Comments on GRVA-11-03

Artificial Intelligence and Vehicle Regulations

Figure 1 – Relationship between AI related standards

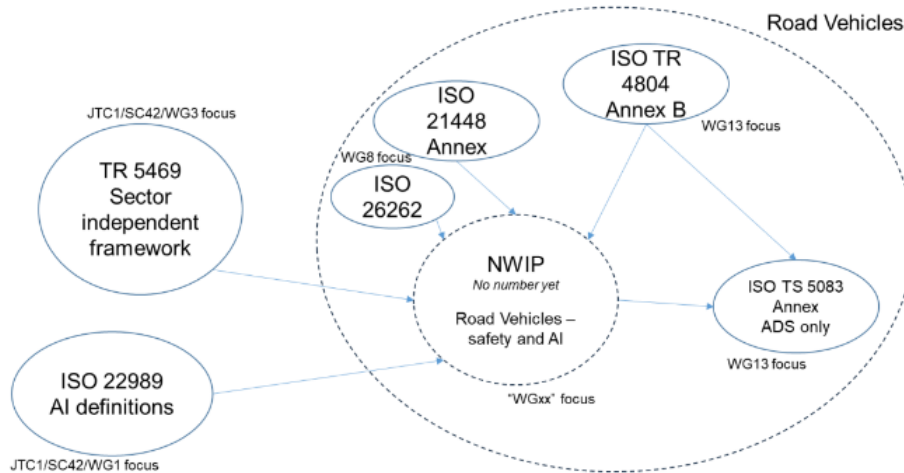
ISO 22989 represents a very good basis to consider but remains incomplete to date and some definitions (e.g., AI systems) should be reviewed, considering other proposals, such as those issued in the rest of the regulatory and normative environment (e.g., AI Act proposal)
